Addendum #1 to Update #1 to the Technical Drainage Study for **Summerlin West Village 25**

Sandstone Rise Drive (Street M): Park Drift Trail
(Street K) to Sky Vista Drive

Prepared for Howard Hughes Company, LLC

March 4, 2021

DESIGNED BY: G. BLAKE
DRAWN BY: G. BLAKE
CHECKED BY: G. BLAKE
DATE: MARCH, 2021
DRAWING NO.: 16/32
VERT.: NONE

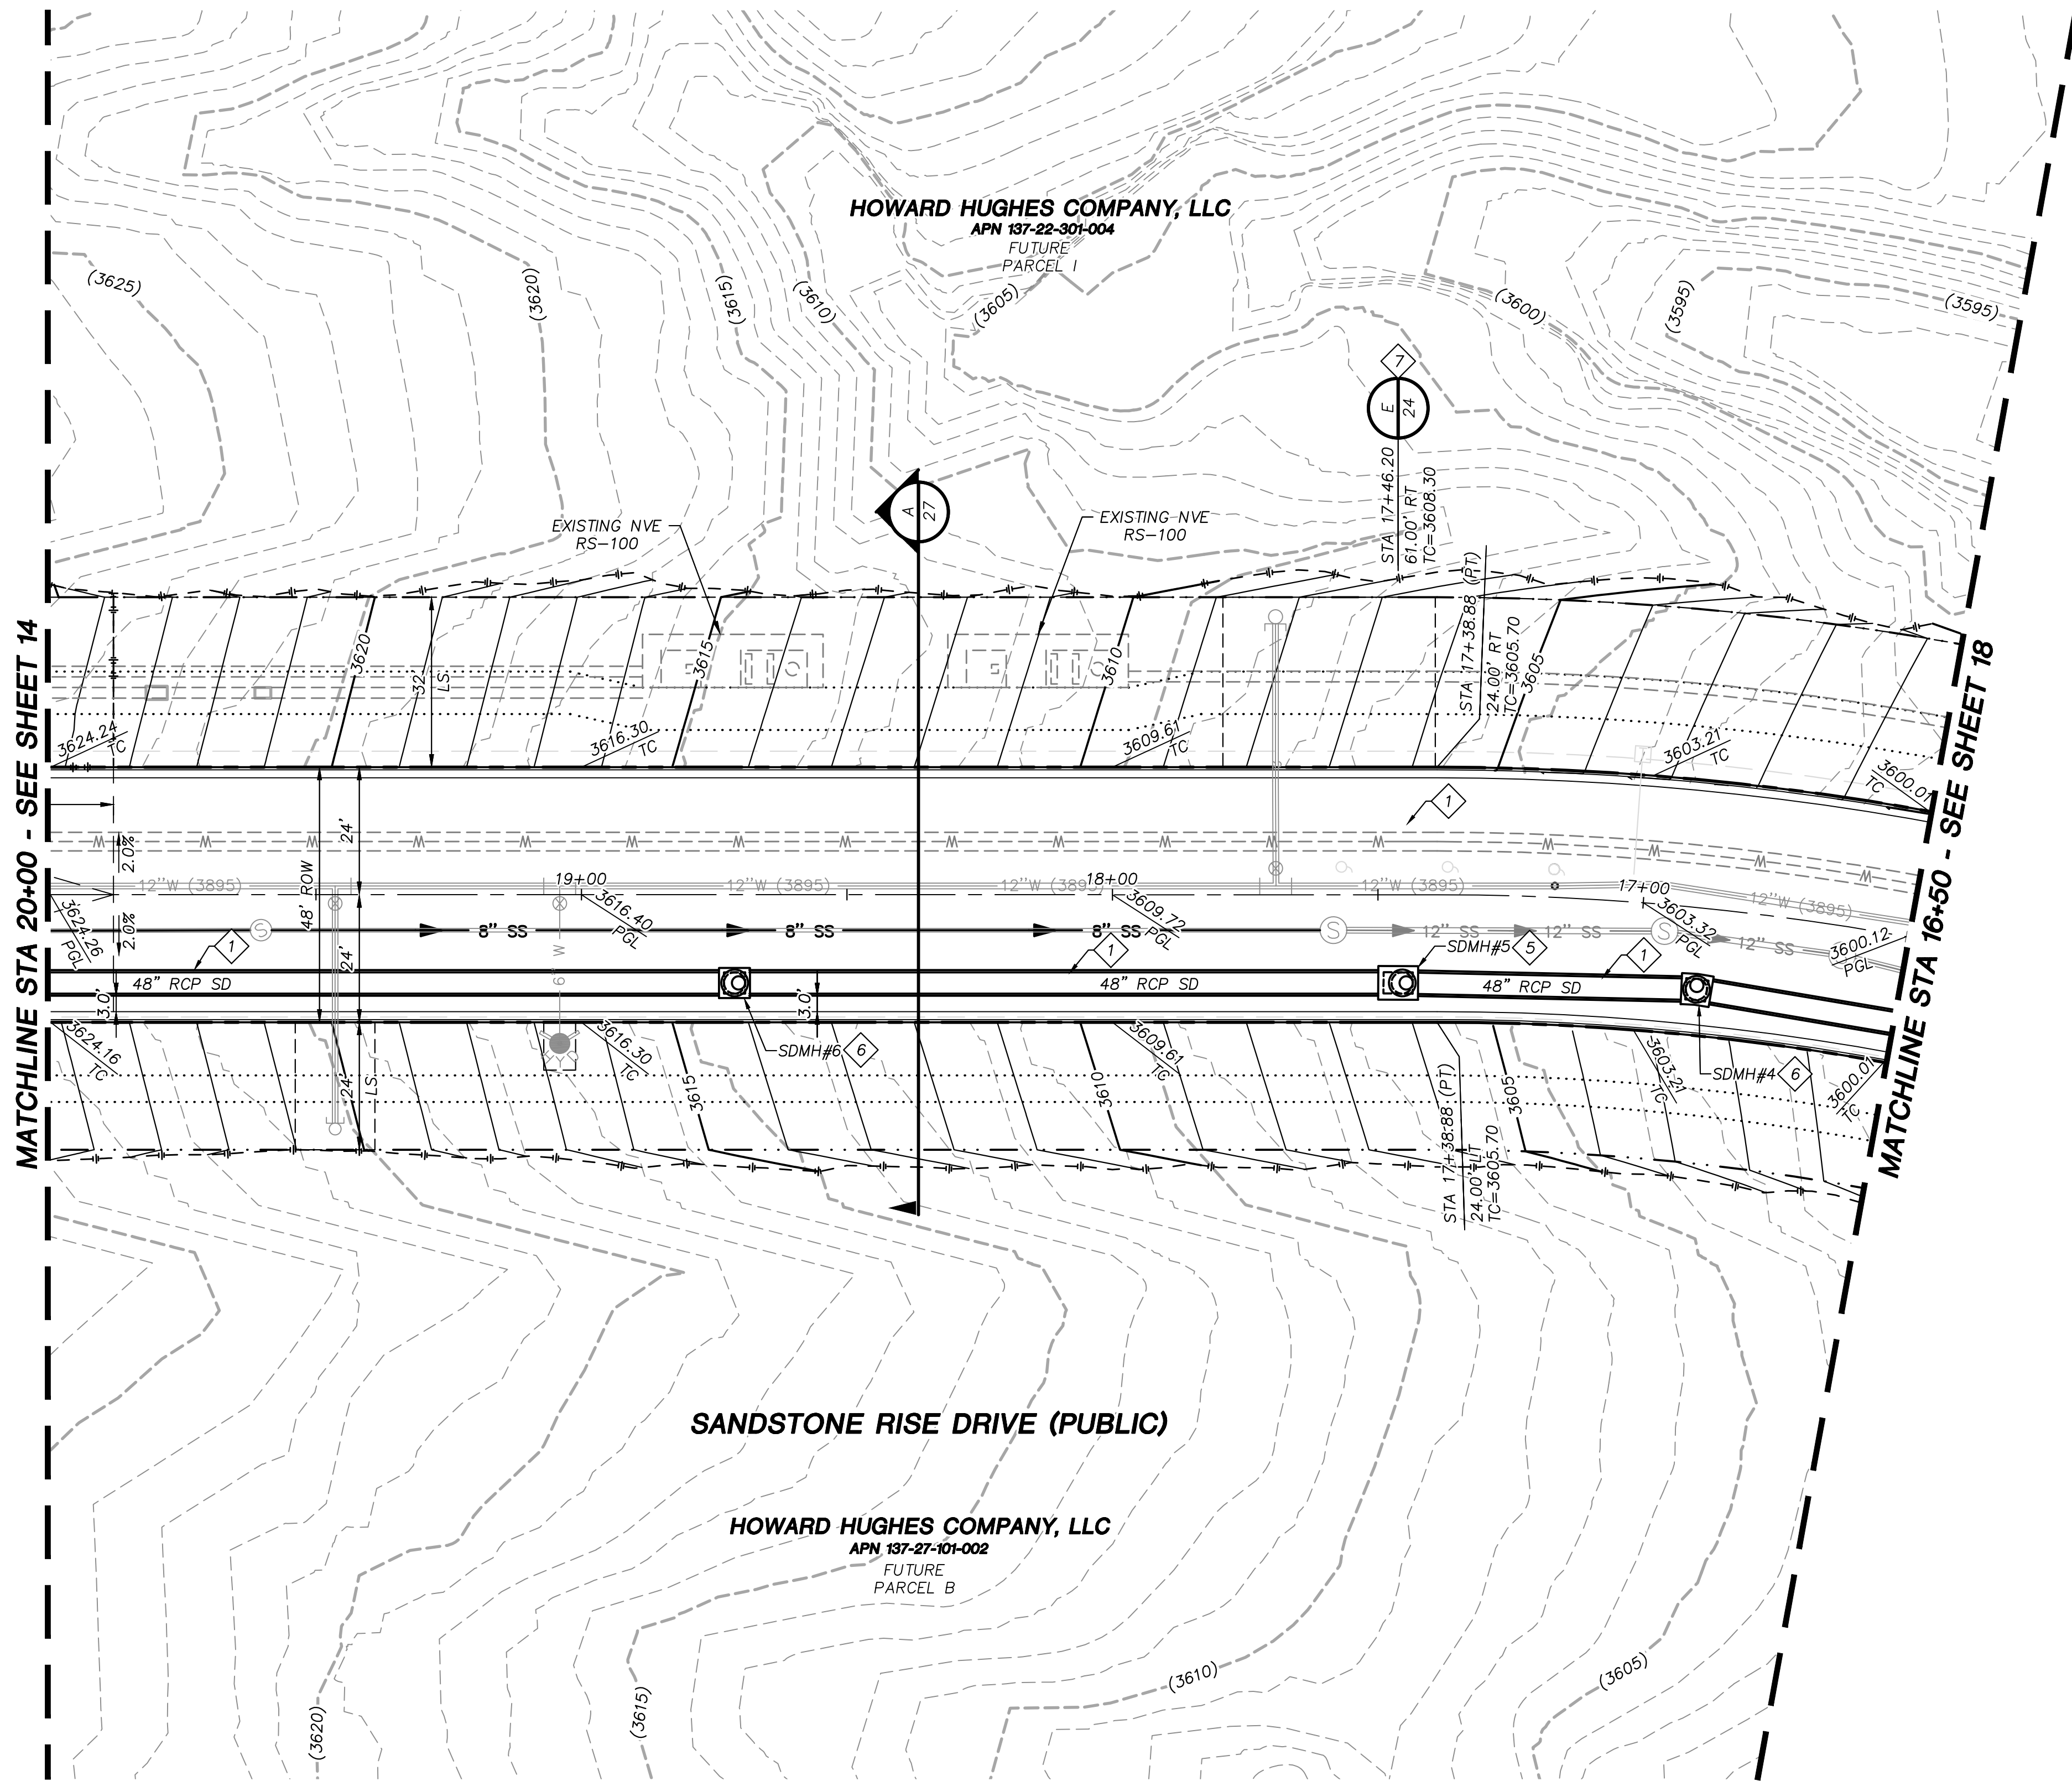
Comment #2: Sheet 18/32 & Sheet 19/32: The linework or symbol for SDMH #3A was missing in both plans.

Comment response: The plans have been updated with the linework and symbol.

DESIGNED BY: G. BLAKE	107Y5132
DRAWN BY: G. BLAKE	L20-00453
CHECKED BY: T. ORTIZ	DATE: MARCH, 2021
HORIZ.: 1" = 20'	DRAWING NO.
VERT.: 1" = 5'	17/32

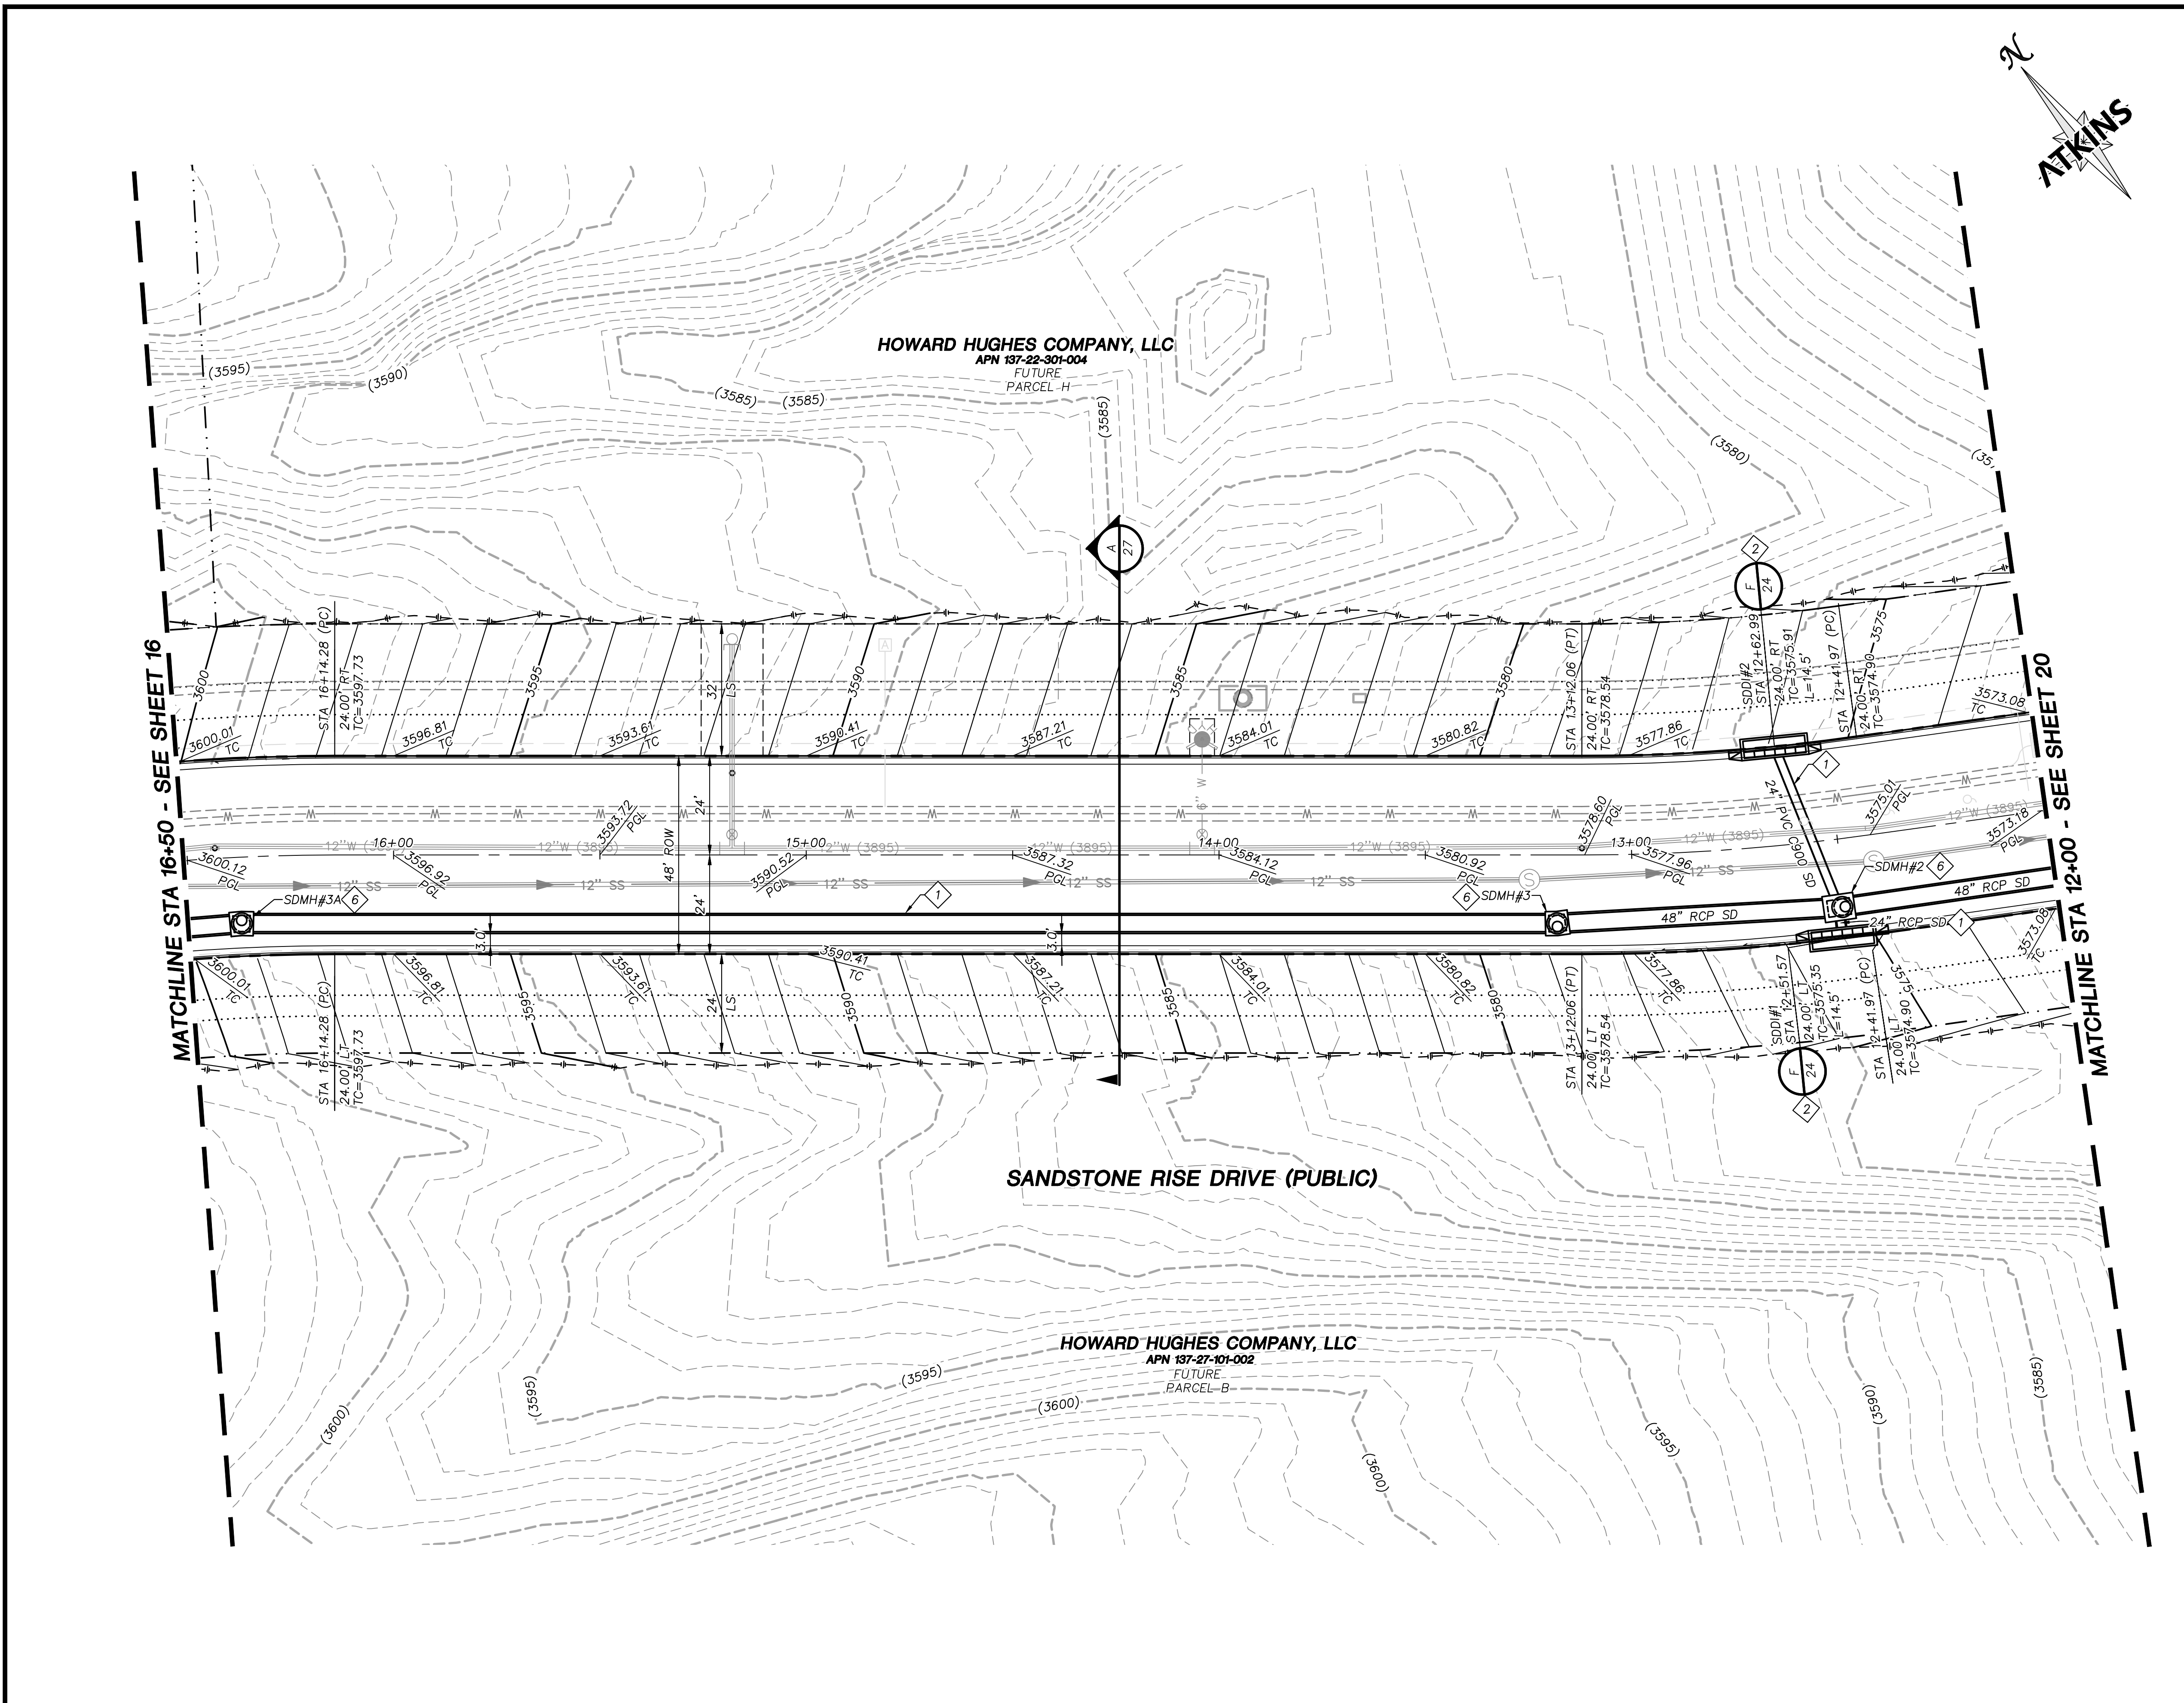
Comment #1: Sheet 15/32 & Sheet 22/32: The revised storm drains connected at SDMH#7 (42"-PVC, 36"-RCP and 48"-RCP) are all very shallow to the street surface. Constant repair and maintenance will be a burden to the City. Address and resolve in the next submittal.

Comment response: An additional profile over the subject storm drain has been provided to show the actual depth over the pipes rather than the relative depth from the street centerline. Clearances at crossings of the existing NV Energy conduits and 24" waterline make deeper storm drain pipe depths not an option. Hydraulically equivalent horizontal elliptical pipes are not available in C-900.
